# SERVICE BULLETIN

Model	Applicable To	File Under	Bulletin #
1988 - 93 PRELUDE	ALL	BODY	93-012
			Issue Date FEB 19, 1993

## Squeak From Center Console

#### 1988-91 Prelude

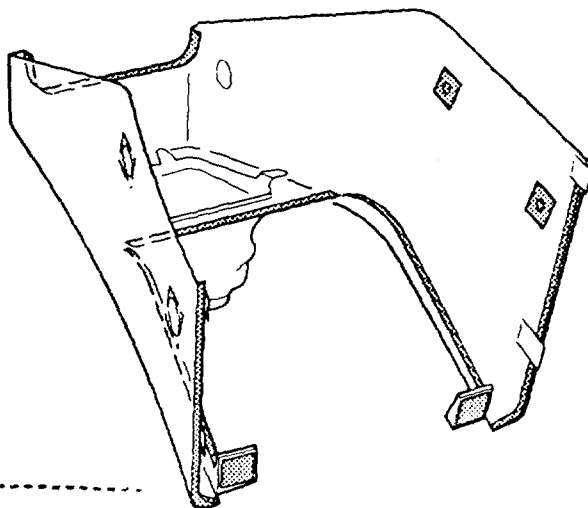
A squeaking noise from the center console.

Friction between the center console and the instrument panel.

Insulate the points of contact with EPT Sealer or adhesive-backed wool felt.

1. Remove the center console as described in the service manual.
2. Cut strips of adhesive-backed wool felt (P/N 06693-SA5-000). Apply them to all points highlighted in the illustration.
